SPECIFICATION FOR ELECTRONIC LC GATE TELEPHONE SYSTEM

SPECIFICATION NO. RDSO/SPN/TC/51-2021

Revision **2.0**~~1.0~~

TELECOM DIRECTORATE
RESEARCH DESIGNS & STANDARDS ORGANISATION
LUCKNOW-226011

Figure-7 6: Test Setup for Performance Test of electronic LC Gate Telephone System with Station Telephone Unit and 2 Gate Telephones.

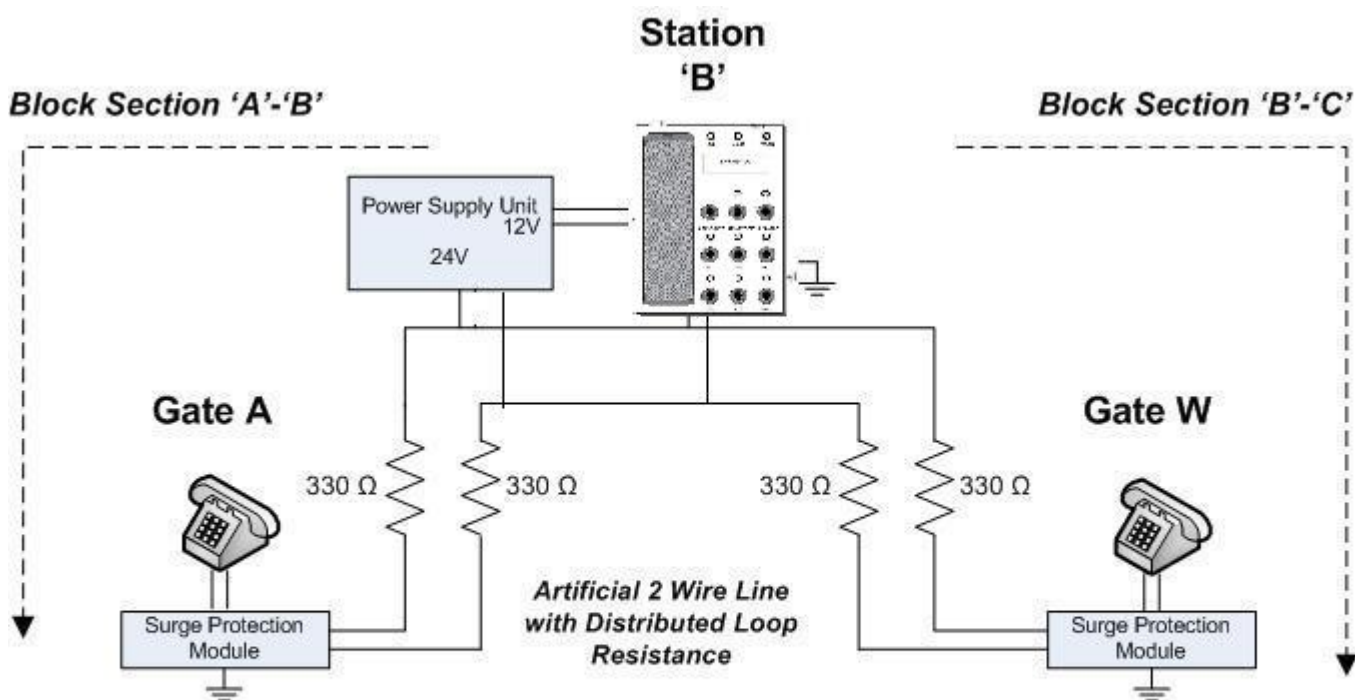
9.1 When Quad is used as media, One Station Telephone Unit and two Gate Telephones are connected together through an artificial line with distributed loop resistance as shown in Figure-5 of Annexure-V. It should be possible to call and get ring on all the Gate Telephones. Speech quality should be good. Gates which are not called by Station Master should neither be able to listen nor talk.

Figure-8-7: Test Setup for Performance Test of electronic LC Gate Telephone System with Station Telephone Unit and 4 Gate Telephones.

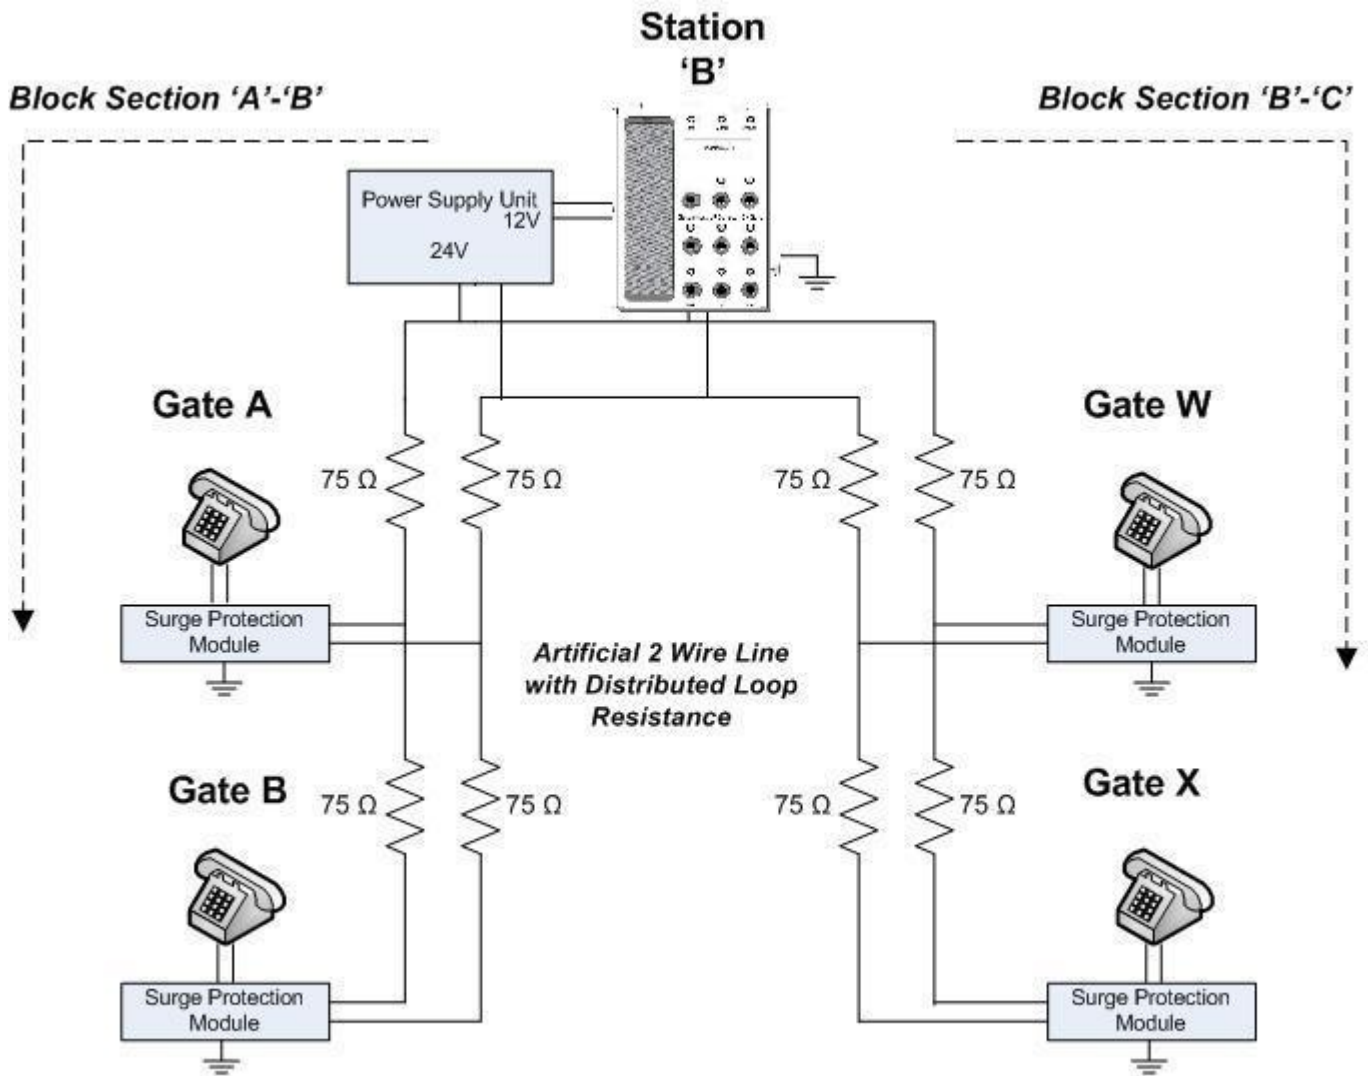
9.2 When Quad is used as media, One Station Telephone Unit and four Gate Telephones are connected together through an artificial line with distributed loop resistance as shown in Figure-6 of Annexure-V. It should be possible to call and get ring on all the telephones. Speech quality should be good. Gates which are not called by Station Master should neither be able to listen nor talk.

Figure-9 8: Test Setup for Performance Test of electronic LC Gate Telephone System with Station Telephone Unit and 6 Gate Telephones.

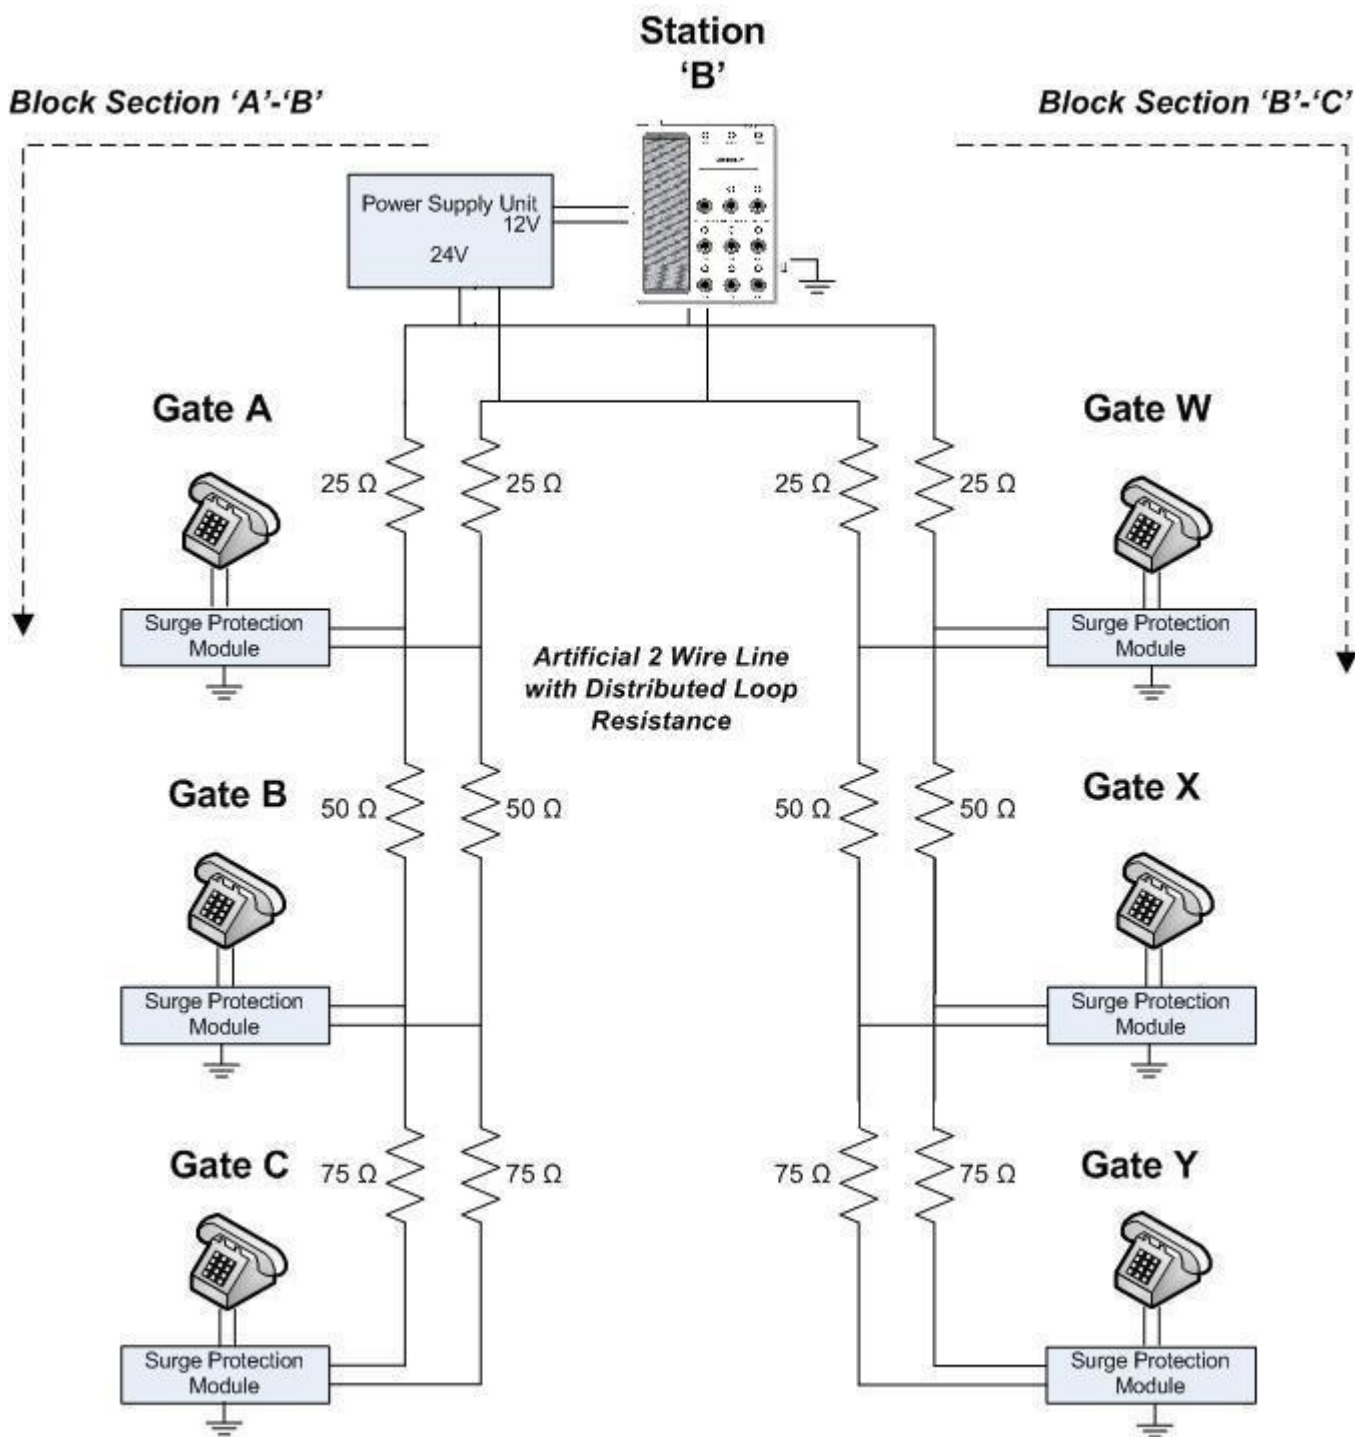
One Station Telephone Unit and Six Gate Telephones are connected together through an artificial line with distributed loop resistance as shown in Figure-7 of Annexure-V. It should be possible to call and get ring on all the telephones. Speech quality should be good. Gates which are not called by Station Master should neither be able to listen nor talk.

FIG-9

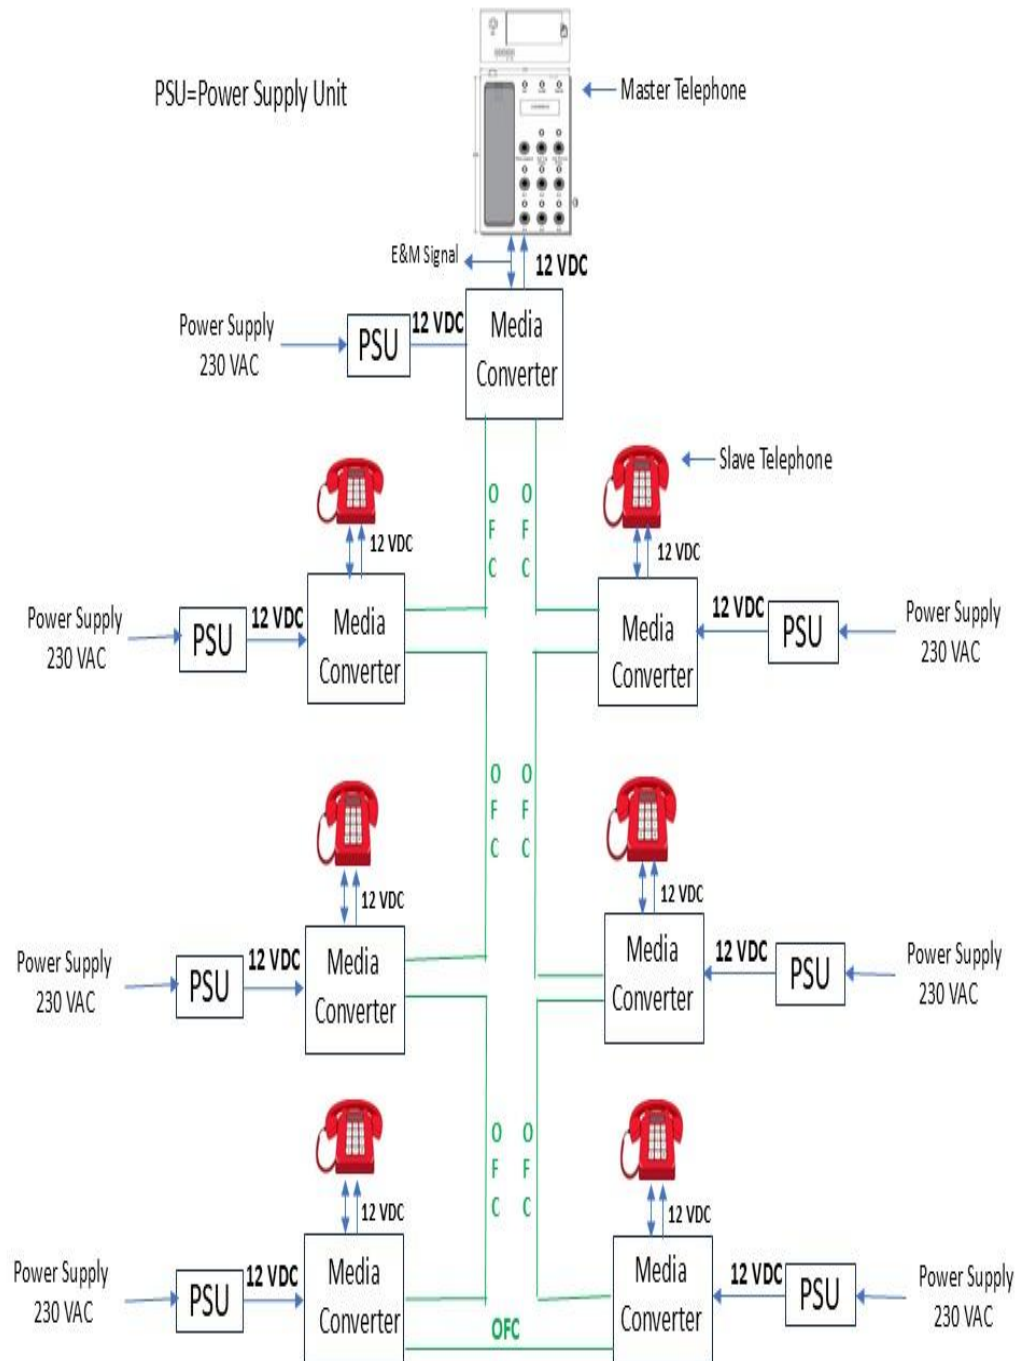
- 4.1 ~~One DC Power source~~ In case of quad cable, Power Supply Unit having 12 V and 24 V DC Output Terminals will be required at a centralized place. Station Telephone Unit and all the 6 Gate Telephones connected as per Figure-1 should work from this Single Power Source and no separate Power supply will be provided at the Gates. In case of OFC, Power Supply Unit will be required at both station and LC Gates arranged as per Figure-9.
